VERMONT YANKEE NUCLEAR POWER STATION

**OPERATING PROCEDURE**

# REVISED PROCEDURE CONTROL FORM

<b>A. Procedure No.</b> OP 3504	<b>New Revision</b> No. 36	<b>Title</b> Emergency Communications	
<b>B. Review Criteria:</b> <input type="checkbox"/> Partial <input type="checkbox"/> Editorial <input checked="" type="checkbox"/> Complete		<b>C. Periodic Review Cycle:</b> <input checked="" type="checkbox"/> 2 Year (Event Driven) <input type="checkbox"/> N/A	
<b>D. List DIs &amp; LPCs:</b> 1, 2, 3			
<b>E. Description and Reasons for Procedure/Changes:</b> <ul style="list-style-type: none"> <li>Updated Figures 4,5,6, and 11.</li> <li>Updated Table 3 and VYOPF 3504.02 to reflect name change of Joint News Center.</li> <li>Changed location of UHF Radio from sprinkler room to Room 123. in EoF</li> </ul>			
<b>F. Originator Name:</b> (App. A was used as references to create this revision, App. C is completed and attached unless Part 1.B above is "Editorial".) (Print/sign/date) Audra Williams <i>Audra Williams</i> 3/11/03			<b>Telephone Extension:</b> x4177

**FIGURE 6**  
**EMERGENCY OPERATIONS FACILITY/RECOVERY CENTER - COMMUNICATIONS ARRANGEMENT**

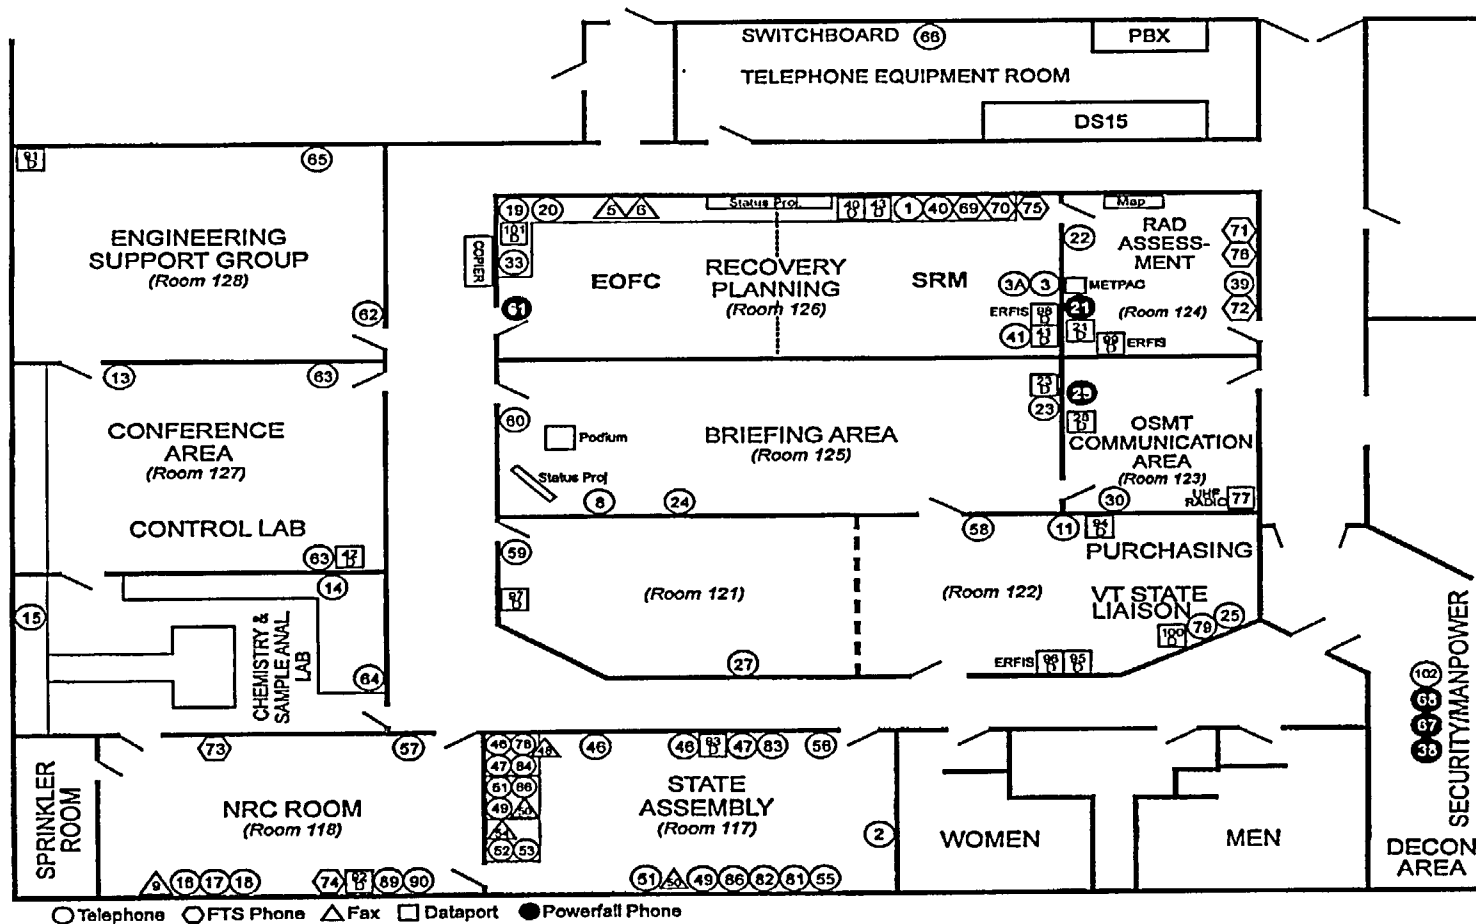
The EOF floor plan was changed to improve the facility. This change required phone extensions and some equipment as well as room designations to change. Manpower/Planning and Personnel & Equip Monitoring supplies were moved to the sprinkler room making it easier to obtain all of their equipment at once. The GHH monitoring team was eliminated and the equipment check needed to be removed from this procedure as well. The CVAX is no longer going to exist and IT changed the login procedure for the DECNET terminal which is reflected in the new instructions. Other minor changes identified during surveillances were made to improve procedure.

**FIGURE 11**  
**JOINT NEWS CENTER – COMMUNICATIONS ARRANGEMENT**

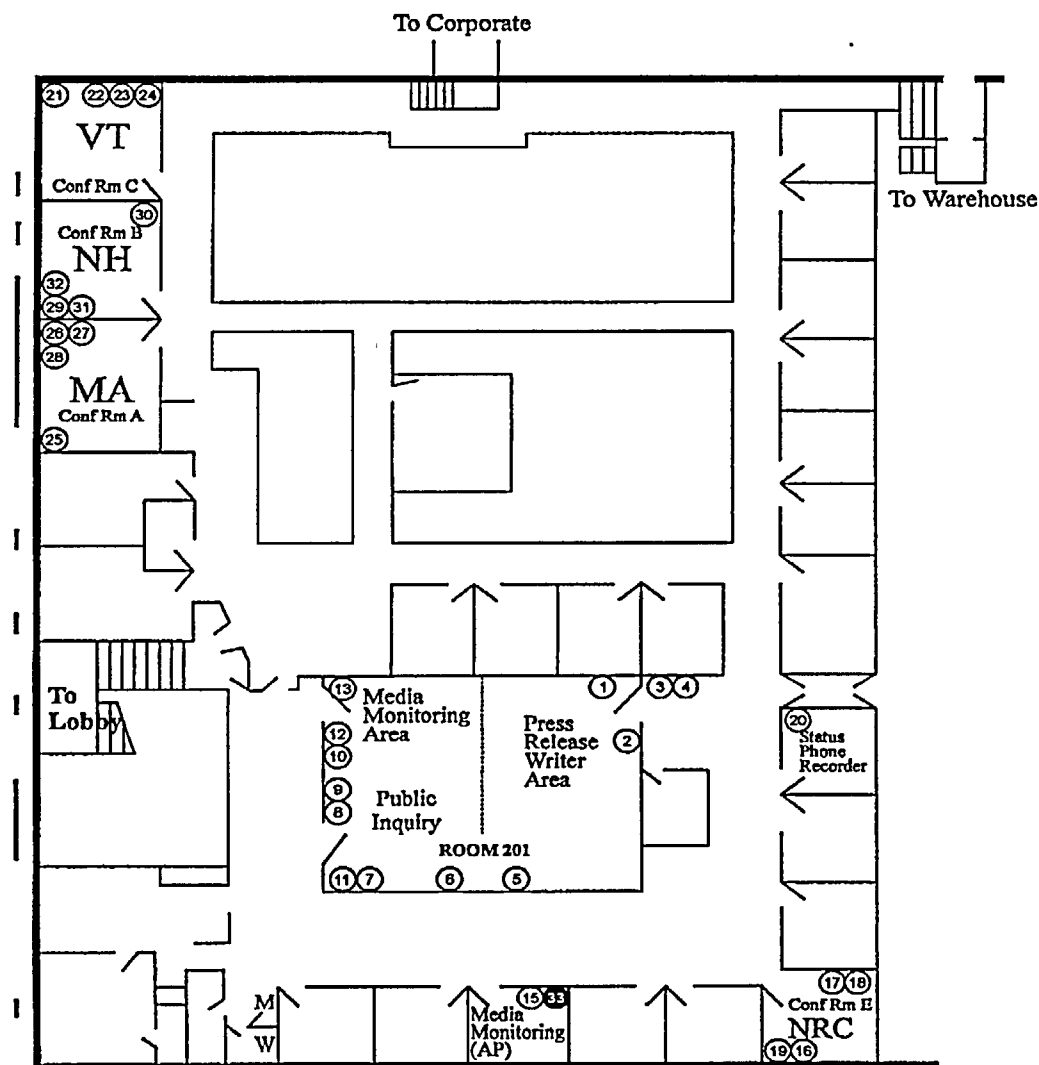
The changes to the Facility Layouts were to correct room names, delete phone designations that were no longer part of the E-Plan, add room numbers and correct the phone designations in the Conf. Rooms in the EOF/JNC. All of these changes were enhancements to the procedure and do not decrease the effectiveness of the Emergency Plan and continue to meet all requirements.
